CITY OF  
**West Linn**

**PLANNING MANAGER DECISION**

FILE NO.: DR-23-10/FMA-23-04

REQUEST: Approval of a Class I Parks and Natural Area Design Review and Flood Management Area Permit at Maddax Woods Park, 5785 River St

TVFR Permit# 2023-0180

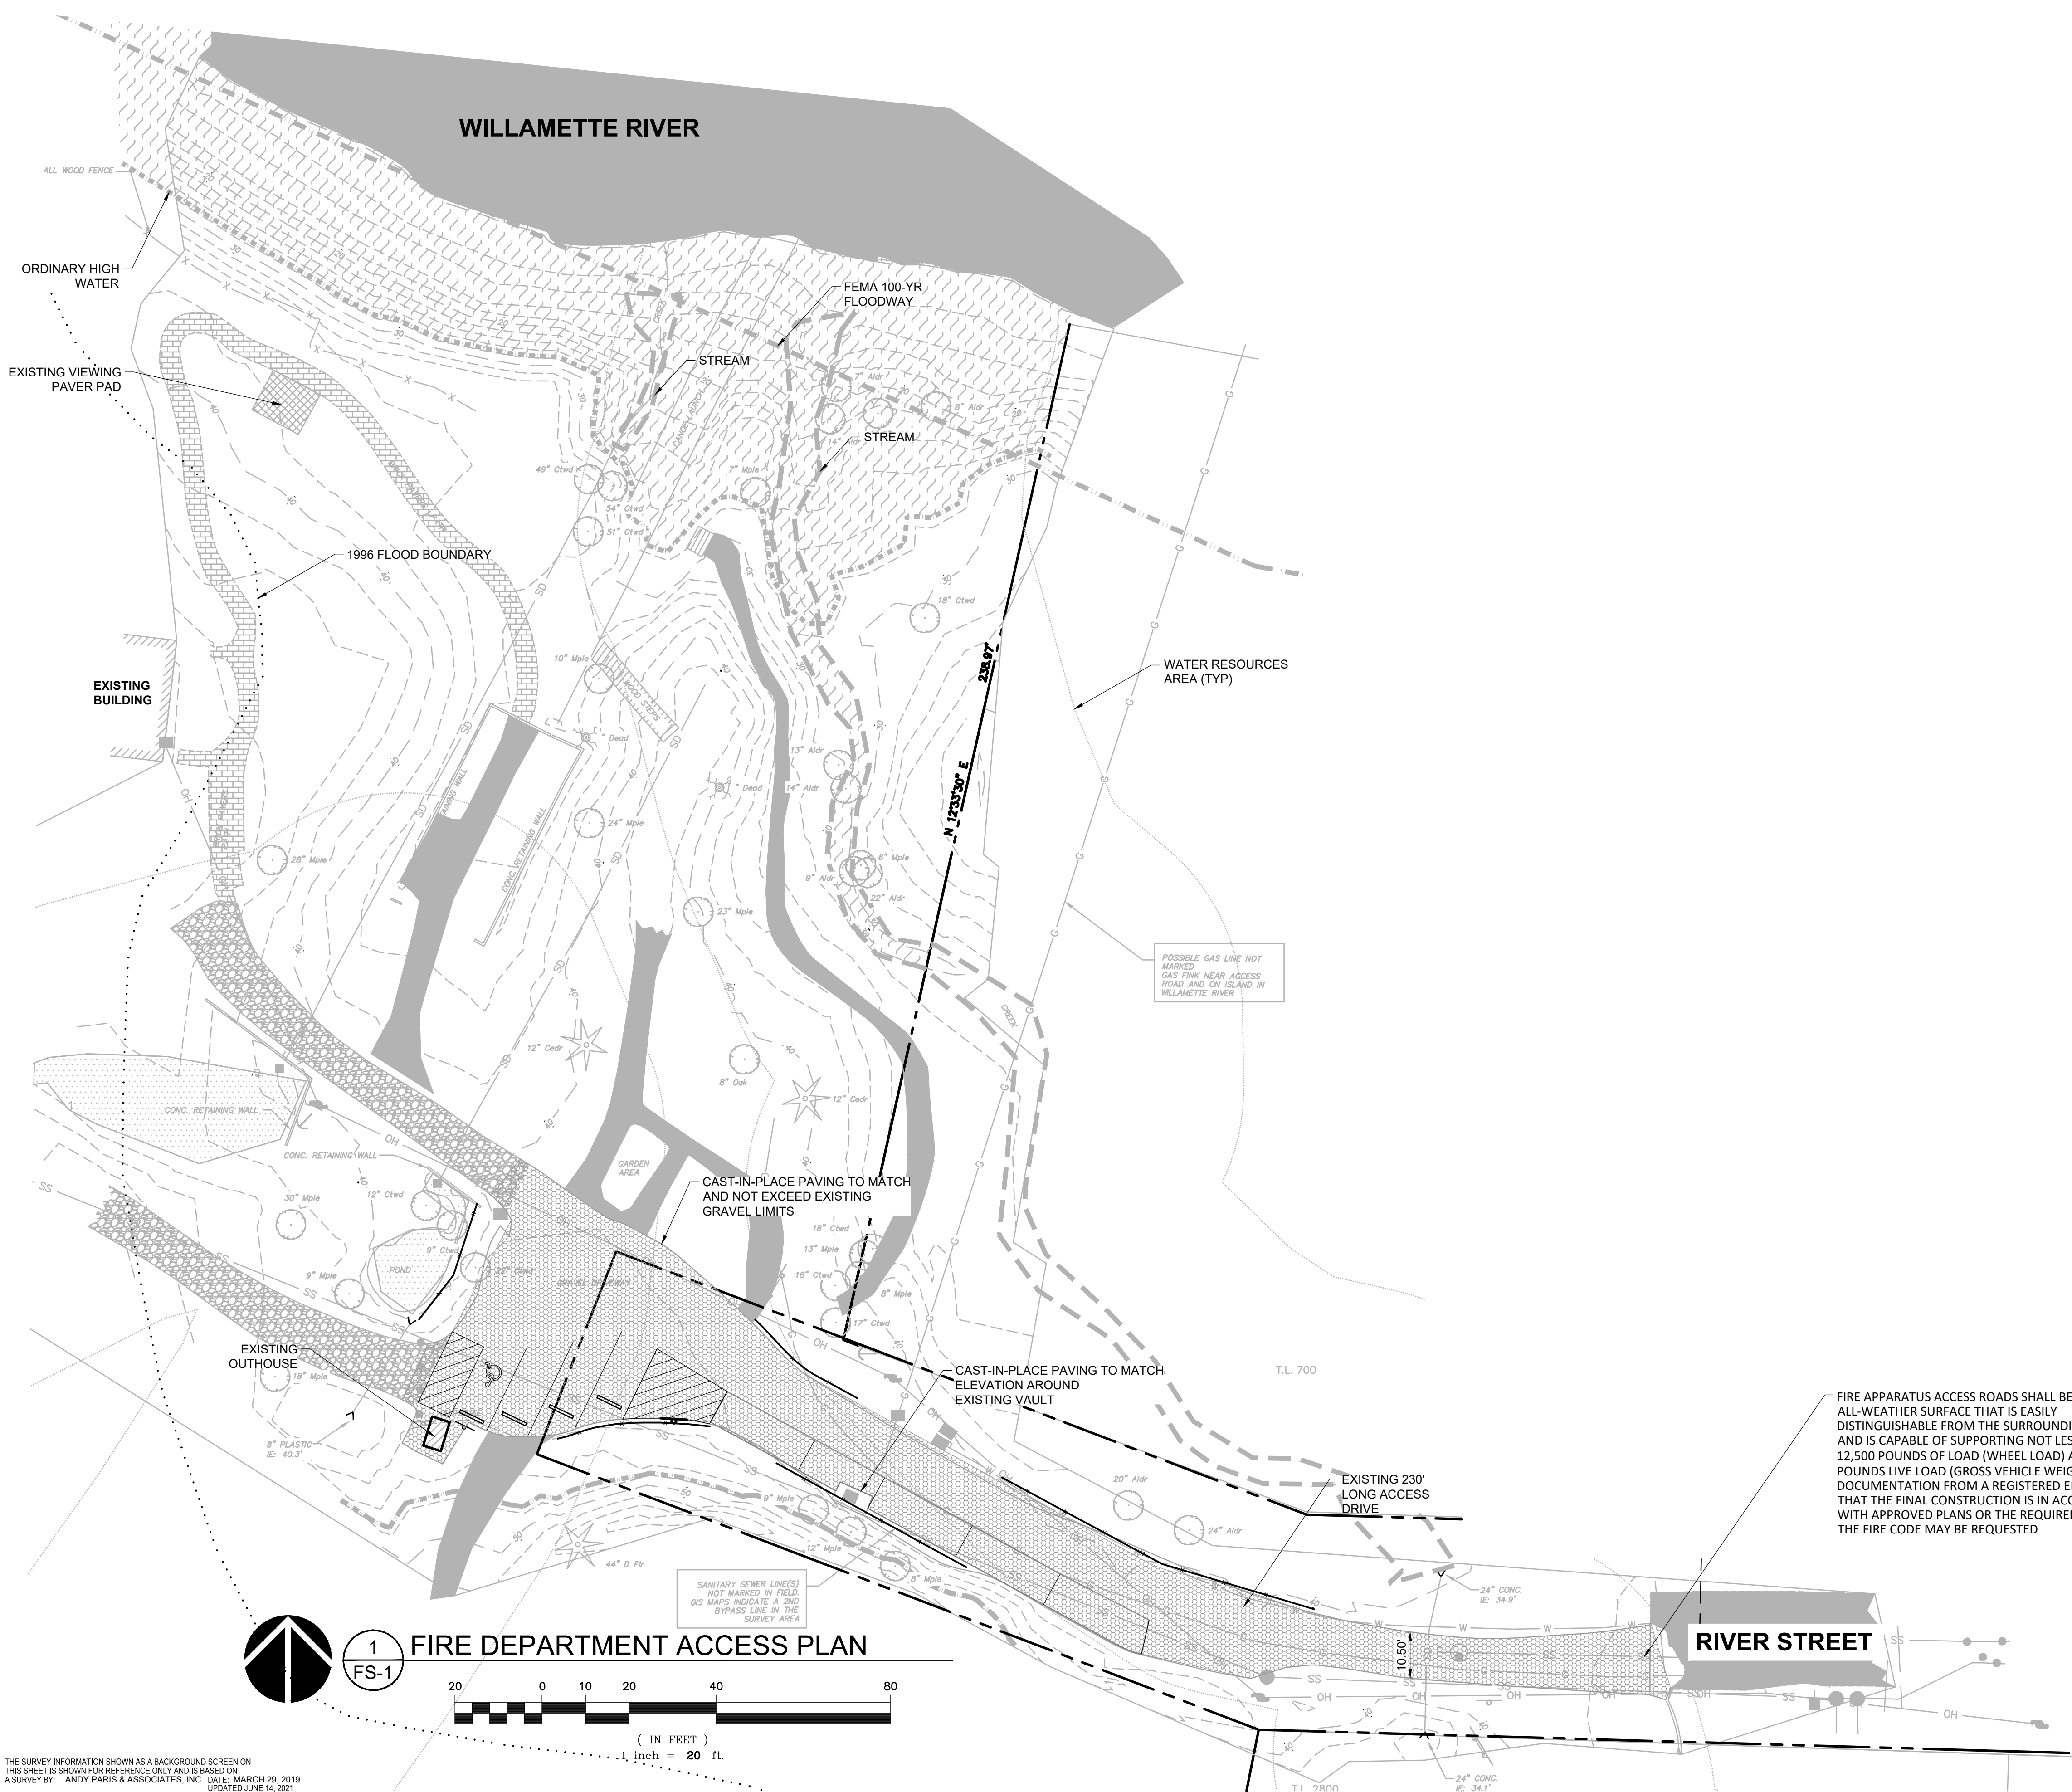
[Signature] 11-13-23  
 Fire Marshal or Designee Date  
 Conditions: See approved plans.

FD Notes: Existing gravel driveway is being replaced with new surface.
